## CITY OF ALBUQUERQUE

Re: Bernalillo County Animal Care and Resource Center

**Traffic Circulation Layout**

Engineer's/Architect's Stamp dated 12-4-15 (M13-D005)

**TCL**

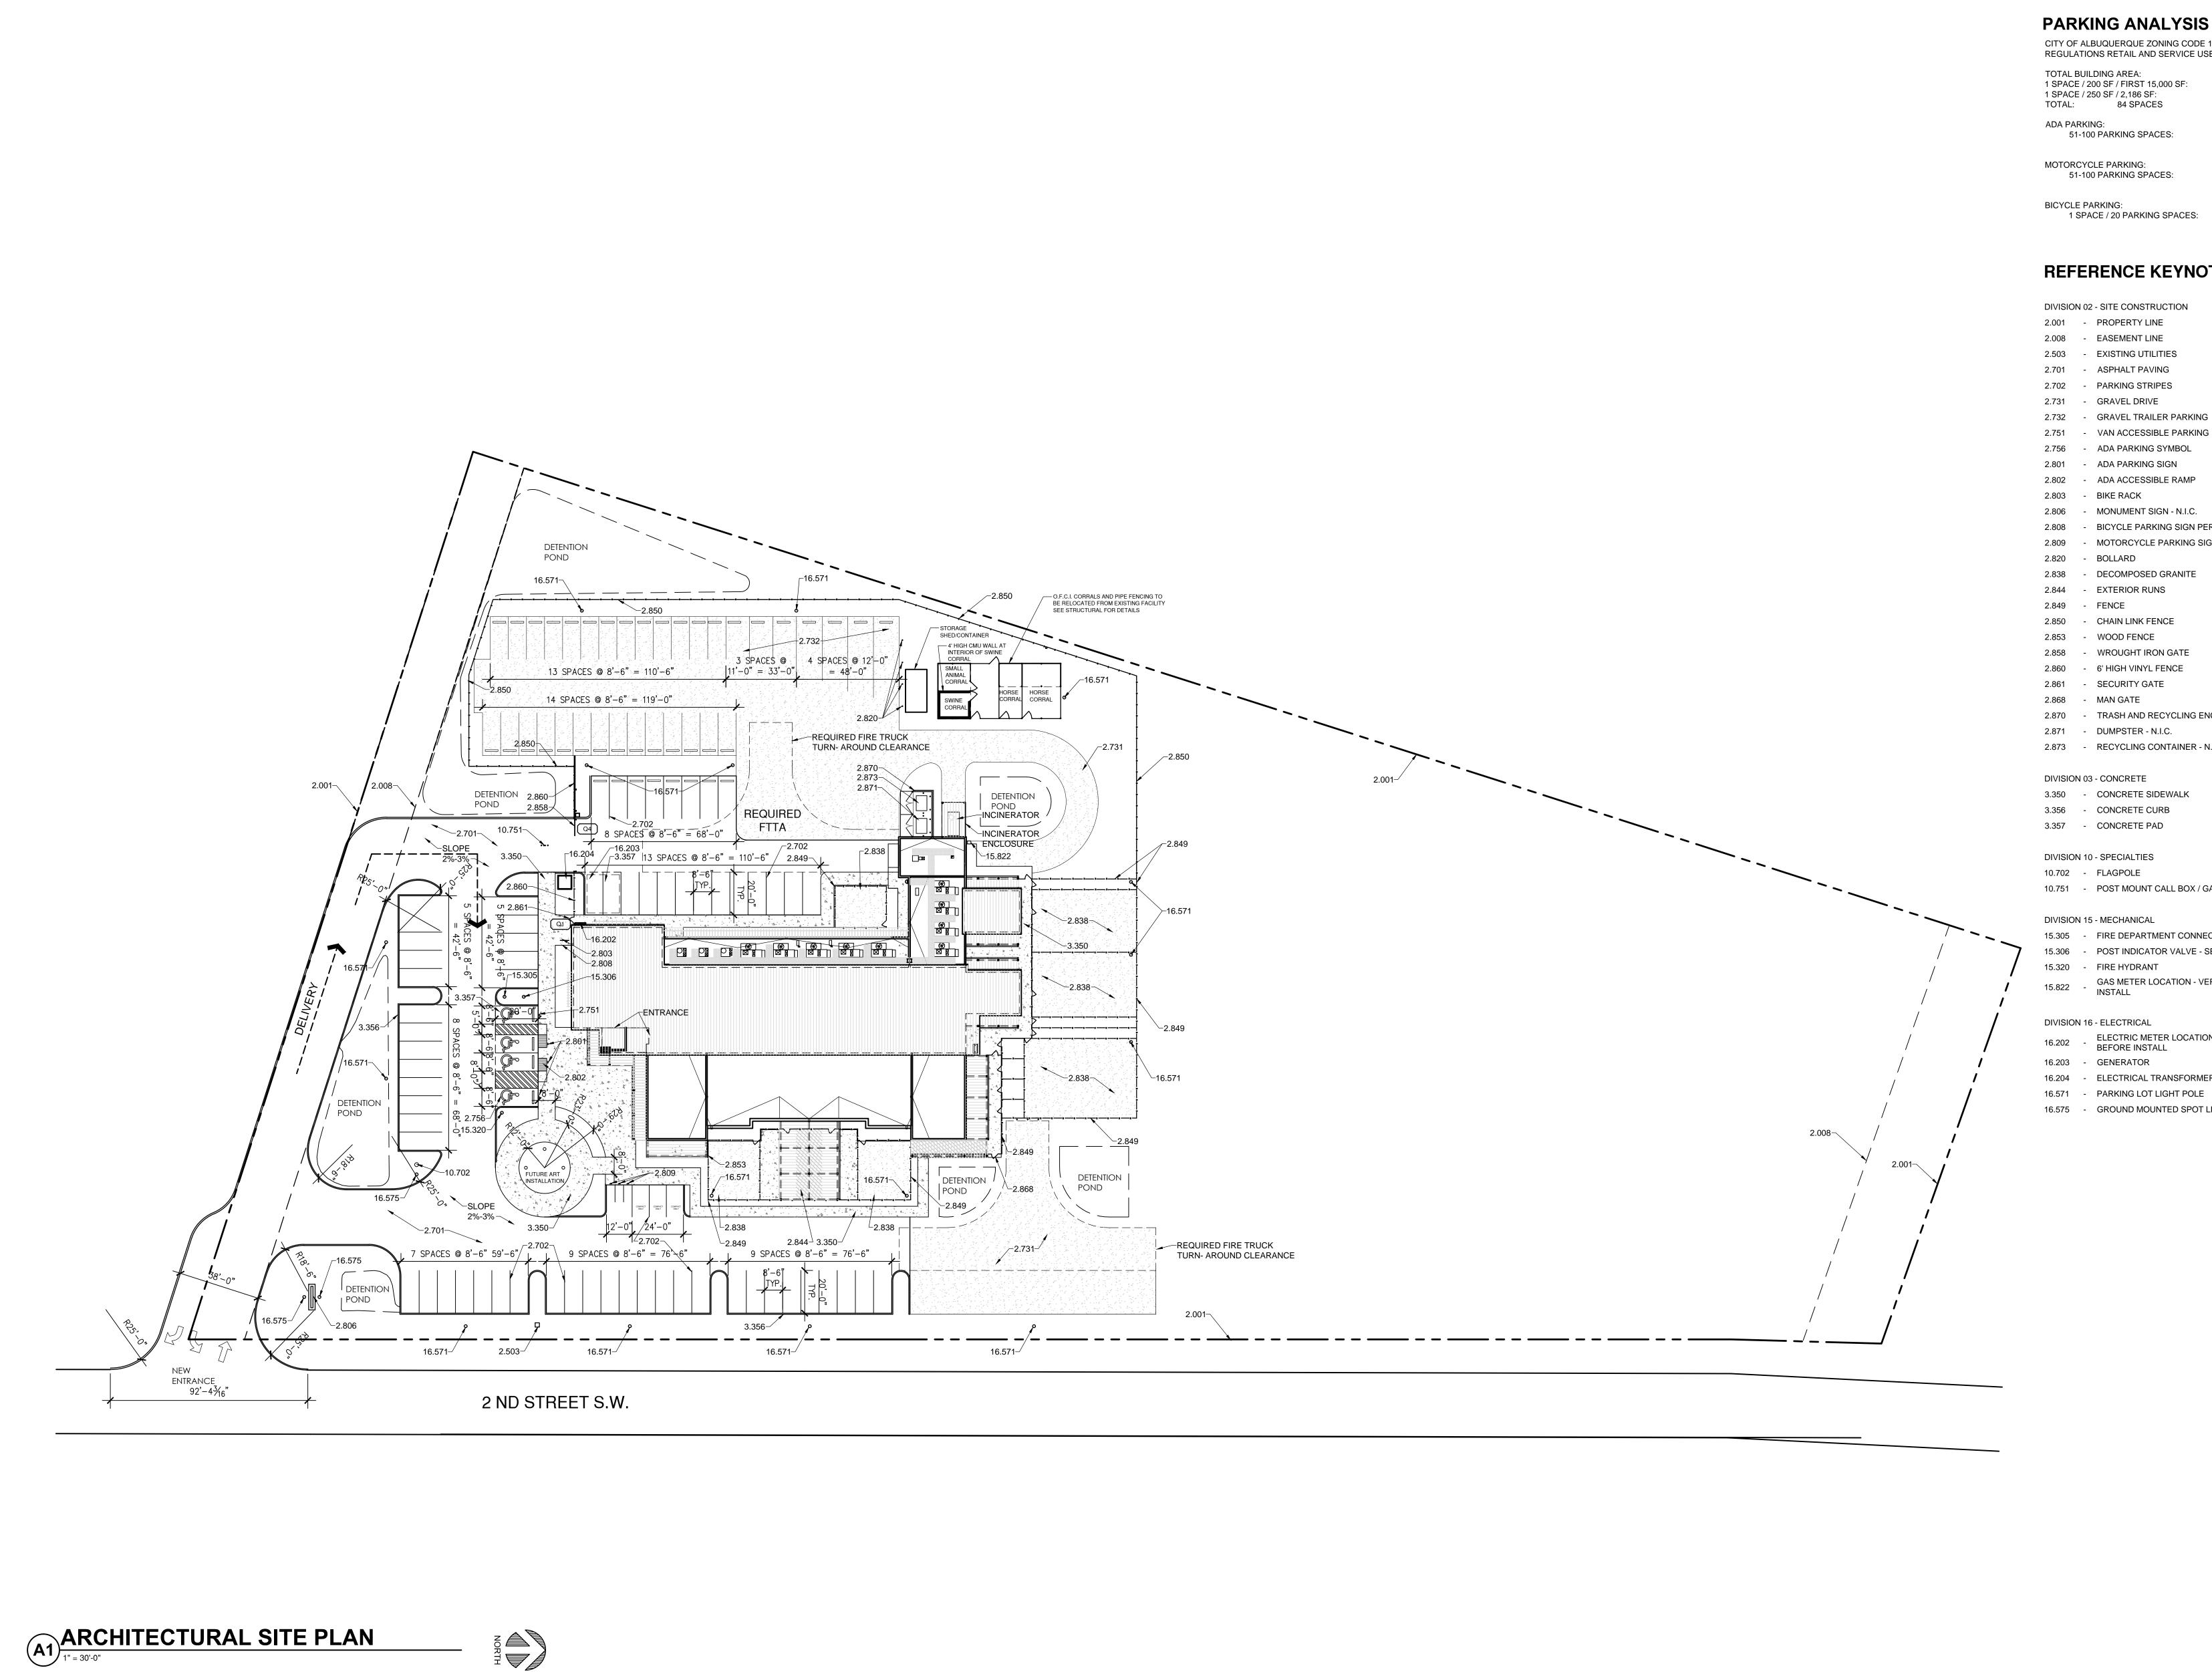
- 1. Please show a vicinity map showing the location of the development in relation to streets and well known landmarks.
- 2. List the number of parking spaces required by the zoning code as well as the proposed number of parking spaces.
- 3. The parking spaces labeled in the same location as a concrete pad for generator cannot be counted in the total parking space calculations.
- 4. Please identify all existing buildings, doors, structures, sidewalks, curbs, drive pads, walls and anything that influences the parking and circulation on the site.
- 5. Identify all existing access easements and rights of way with dimensions.
- 6. Identify the right of way width, medians, curb cuts, and street width on 2<sup>nd</sup> St.
- 7. Please dimension the distance between all abutting parking spaces.
- 8. Please list the width and length for all parking spaces.

Show all drive aisle widths and radii.

- 10. The ADA accessible parking sign must have the required language per 66-7-
- 11. The ADA access aisle shall have the words "NO PARKING" in capital letters, each of which shall be at least one foot high and at least two inches wide, placed at the rear of the parking space so as to be close to where an adjacent vehicle's rear tire would be placed. (66-1-4.1.B NMSA 1978)

352.4C NMSA 1978 "Violators Are Subject to a Fine and/or Towing."

12. A five-foot keyway is required for dead-end parking aisles. Please show this detail for all dead-end parking aisles.

- 13. Per the DPM, a 6 ft. wide ADA accessible pedestrian pathway is required from the HC parking stall access aisles to the building entrances. Please clearly show and dimension this pedestrian walk way.

- 14. Please detail and call out COA Standard Drawings for ADA ramps to pedestrian walk ways.
- 15. Provide a min 6" or max 8" high concrete barrier curb or other acceptable barrier between landscaping and parking areas and/or drive aisles. Please call this detail.

- 16. Service vehicle and/or refuse vehicle maneuvering must be contained on-site; provide a copy of refuse approval.
- 17. It is not apparent what type of pavement surface is being proposed. A hard driving surface will be required as part of this proposed project for parking area and drive aisles. Please detail the type of engineered surface materials proposed for both the paved and graveled parking spaces and drive isles.

- 18. Please provide a sight distance exhibit (see the *Development Process Manual*, *Chapter 23, Section 3, Part D.5 Intersection Sight Distance*). Please show this detail for entrance on 2<sup>nd</sup> St.

- 19. Please add the following note to the clear sight triangle: "Landscaping and signage will not interfere with clear sight requirements. Therefore, signs, walls, trees, and shrubbery between 3 and 8 feet tall (as measured from the gutter pan) will not be acceptable in this area."
- 20. Please include two copies of the traffic circulation layout at the next submittal.
